ATTACHMENT 1 – Council Submission

SSD-88511459 – 33-37 Herbert Street, St Leonards

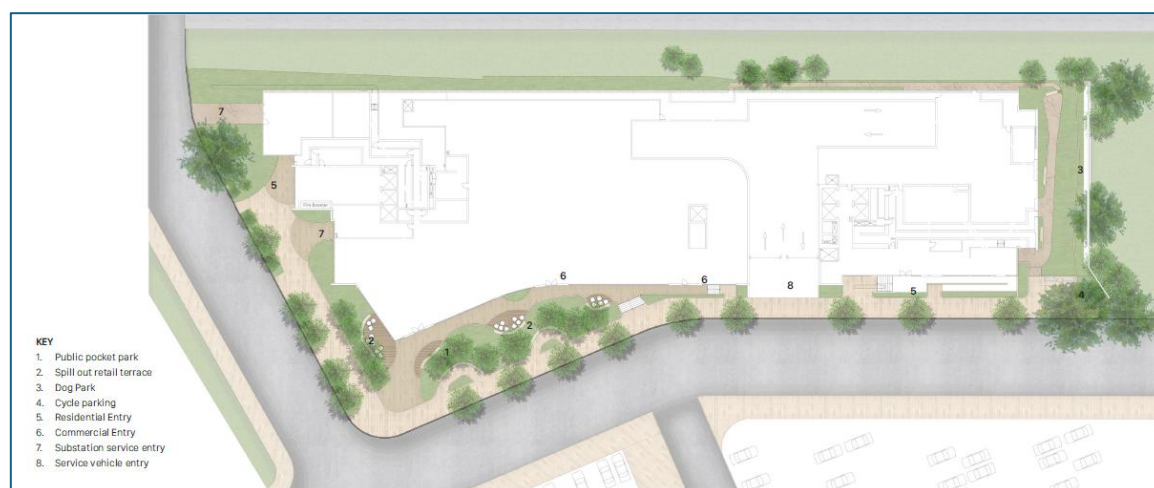
The Infrastructure Needs Assessment provides a limited assessment of capacity for childcare facilities and preschools, but does not provide a detailed assessment on the demand or capacity for the broader range of public infrastructure required to service future residents. This analysis is essential to understand both the projected demand for, and available capacity of, various infrastructure facilities. While various infrastructure facilities are located within walking distance of the site, accessibility does not, in itself, demonstrate that these facilities have sufficient existing or future capacity to accommodate additional demand.

Based on this lack of evidence and analysis, it cannot be concluded that existing infrastructure in St Leonards and surrounding suburbs has sufficient capacity to service the future projected population. This includes not only future residents of the subject site, but also the broader projected residential uplift within the St Leonards and Crows Nest

The Department should therefore request a more detailed and holistic public infrastructure assessment to determine whether existing and planned public infrastructure has sufficient capacity to accommodate the proposed residential uplift. Council expects the proposal will exacerbate existing challenges with respect to provision of recreation spaces and facilities and the proposal should include provision to mitigate these impacts beyond the local contributions payable.
